# Access Compliance Report Public Rights-of-Way (Curb Ramps)

Main Street: BOUVAIS\_RD Cross Street: CHANTICLEER\_RD Location: NE

ADA ID: RPRK210923134405 Ramp Type: Type 1 - Perpendicular Diagonal Initial Pass/Fail: Fail Overall Compliance: No Severity Score: 32

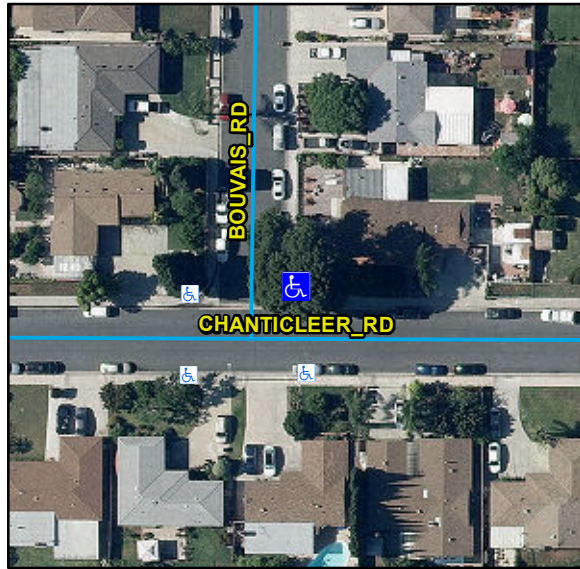
| Compliance | Description                           | Data | Compliance | Description                   | Data |
|------------|---------------------------------------|------|------------|-------------------------------|------|
| No         | Ramp Run Slope (%)                    | 13.6 | N/A        | Flare Slope LT (%)            | N/A  |
| No         | Ramp Cross Slope (%)                  | 2.4  | N/A        | Flare Traversable LT          | N/A  |
| No         | Gutter Lip Height (in)                | 0.25 |            | Road Run Slope (%)            | 0.8  |

**Remove & Replace Curb Ramp With Two New Directional Ramps or Equivalent. Grind Gutter Lip.**

**R204.3, R304.2.2, R304.5.3, R302.7.2, STD 1115**
